UNITED STATES PATENT AND TRADEMARK OFFICE

Office Action Summary	Application No. 10/767,350	Applicant(s) JORANLIEN ET AL.	
	Examiner Charles E. Cooley	Art Unit 1723

NON-FINAL OFFICE ACTION

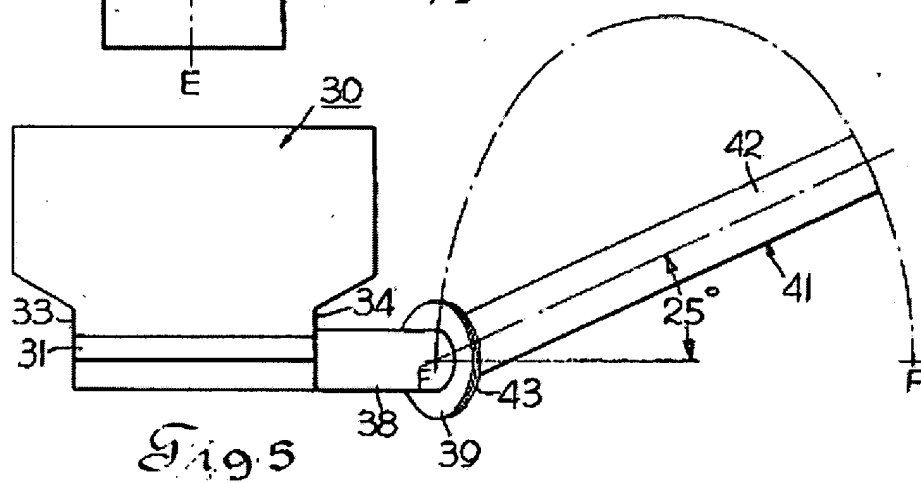
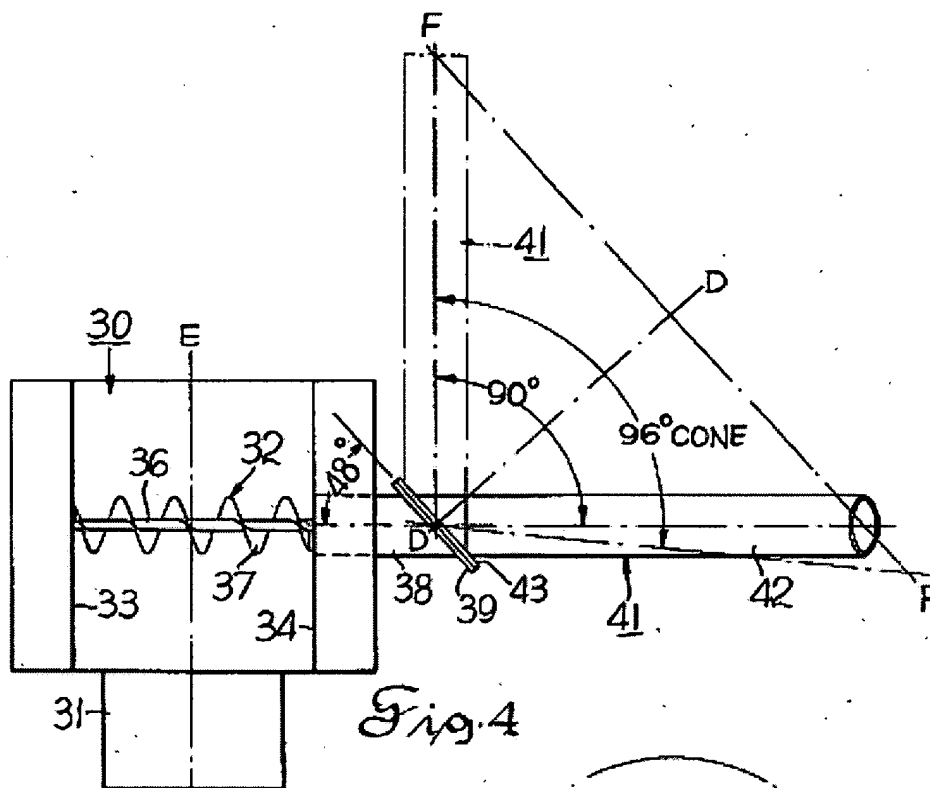
9. **Claims 11-16 are rejected under 35 U.S.C. 102(b) as being anticipated by Boone (US 3,721,333).**

The patent to Boone discloses in Figs. 4-5 as seen below a rotatable auger assembly with cores 32 and 41 that are non-concentric and disposed at an adjustable angle with respect to each other within the recited ranges; and a plate type shim 39 and/or 43 facilitating the angular adjustment.

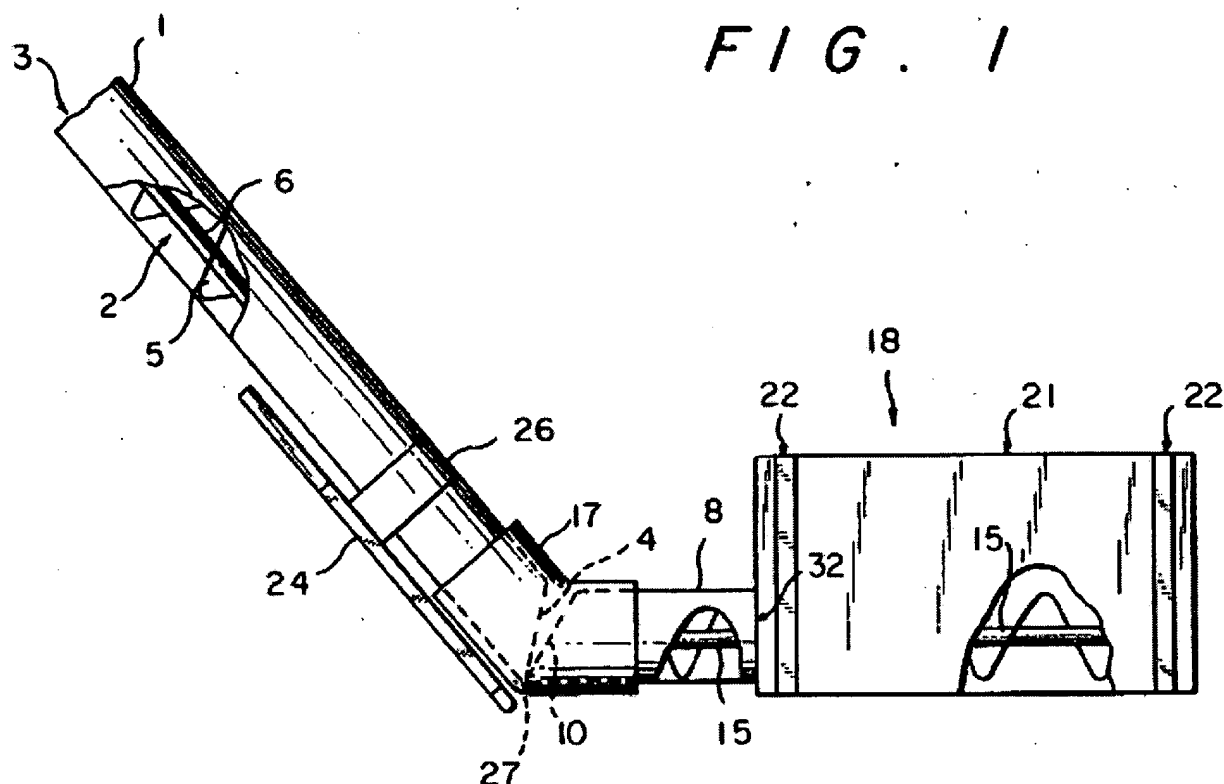
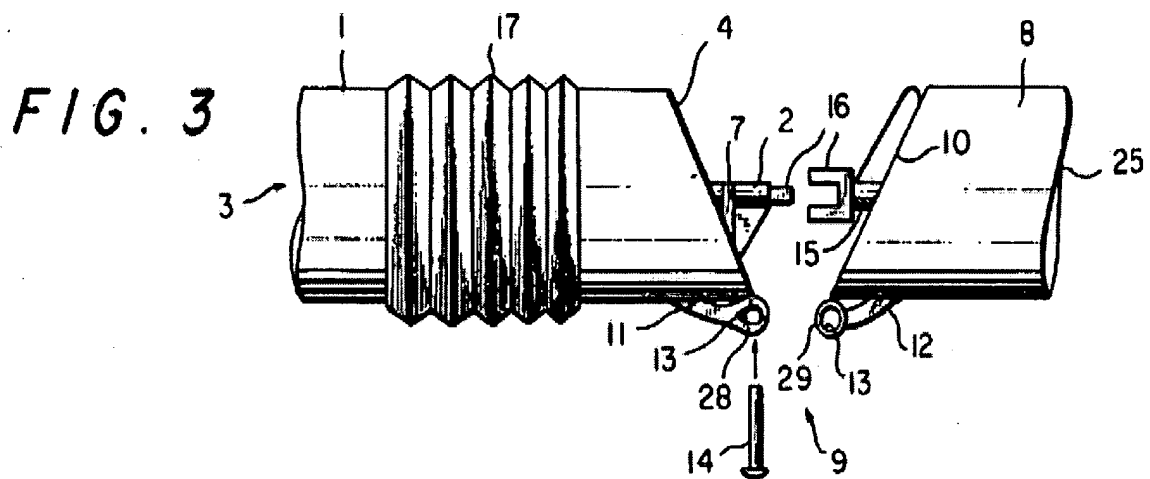
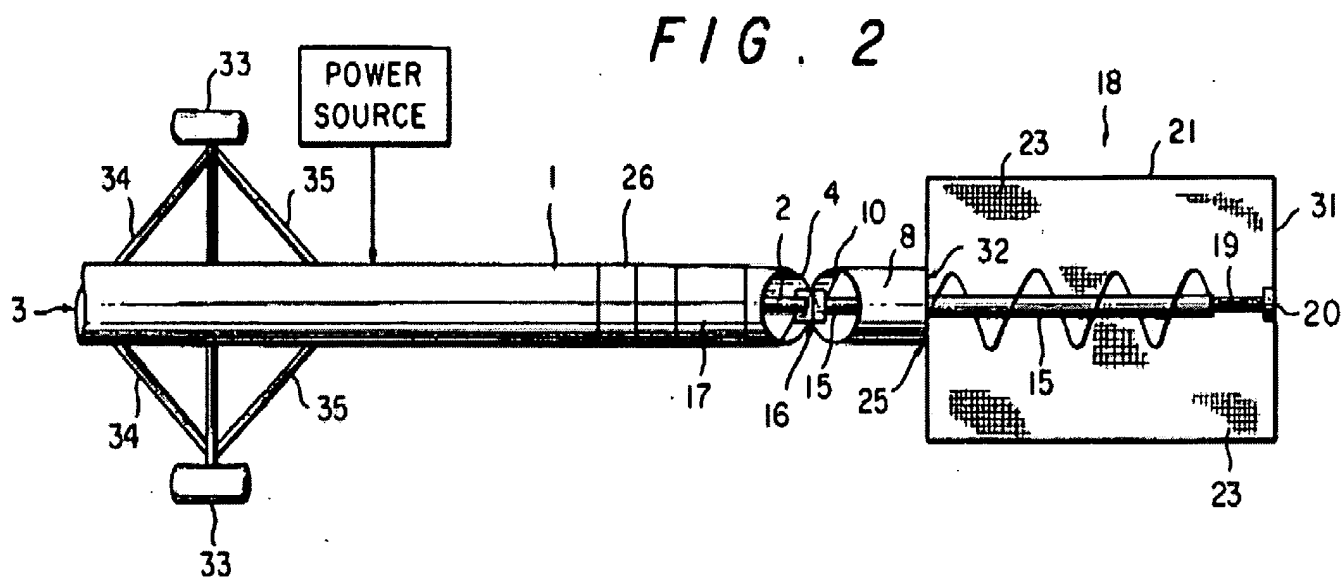
10. Claims 11-16 are rejected under 35 U.S.C. 102(b) as being anticipated by Stuckey (US 4,989,716).

The patent to Stuckey discloses in Figs. 1-3 as seen below a rotatable auger assembly with cores 2 and 15 that are non-concentric and disposed at an adjustable angle with respect to each other within the recited ranges; and a plate type shim 16 facilitating the angular adjustment.

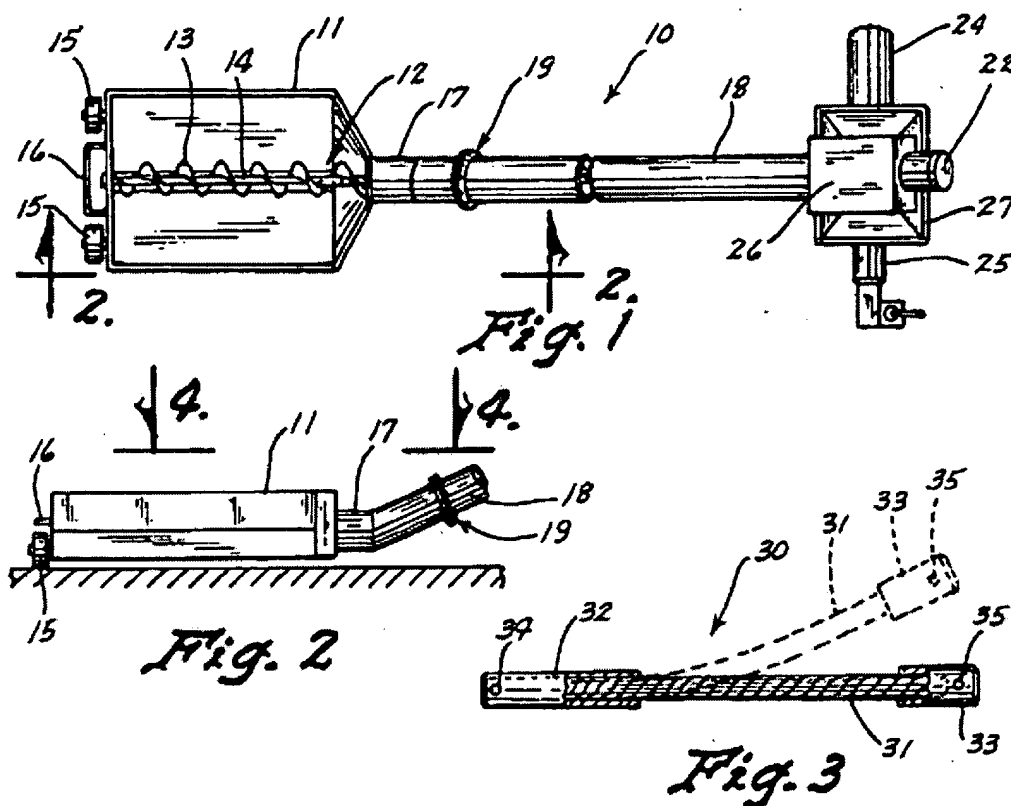
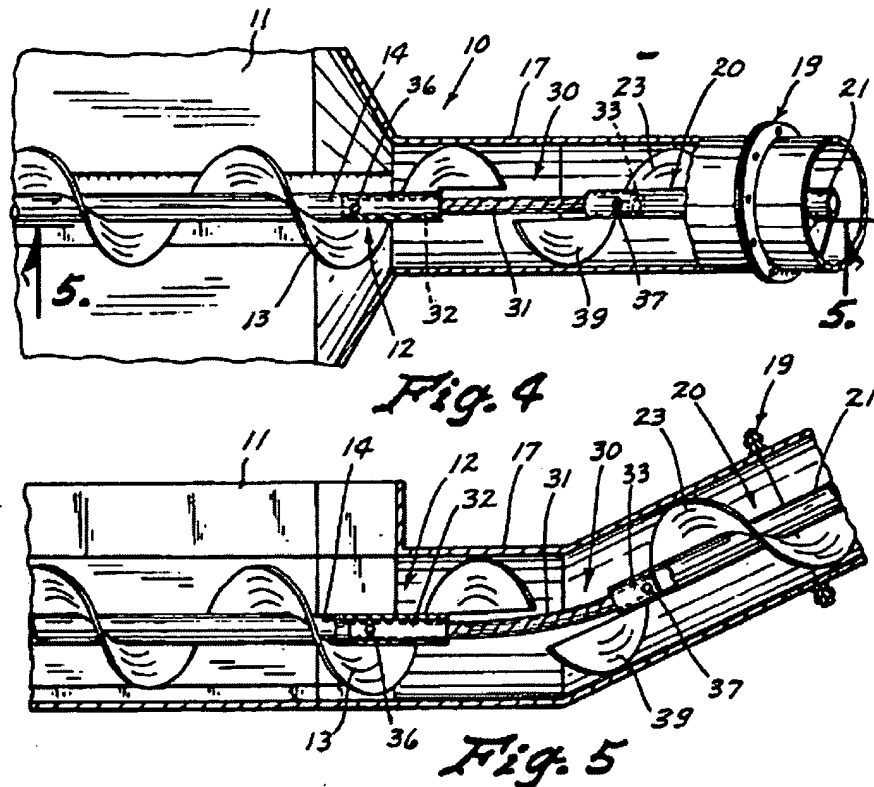
11. Claims 11, 12, 13, 15, and 16 are rejected under 35 U.S.C. 102(b) as being anticipated by Barenthsen (US 5,119,931).

The patent to Barenthsen discloses in Figs. 1-5 as seen below a rotatable auger assembly with cores 14 and 20 that are non-concentric and disposed at an adjustable angle with respect to each other (Fig. 3) within the recited ranges.

Fig. 1

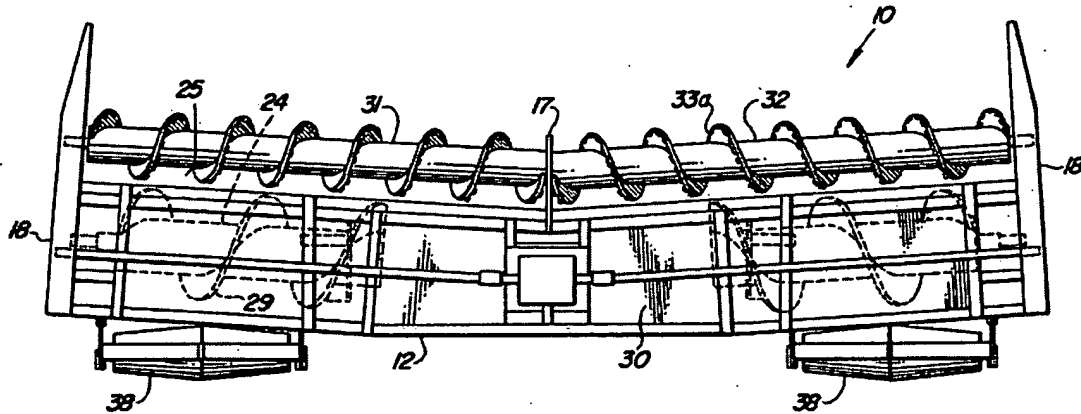
12. Claims 11, 12, 15, and 16 are rejected under 35 U.S.C. 102(b) as being anticipated by Lundahl et al. (US 5,305,586).

The patent to Lundahl et al. discloses in Fig. 1 as seen below a rotatable auger assembly with cores 31 and 32 that are non-concentric and disposed at an angle with respect to each other within the recited ranges.
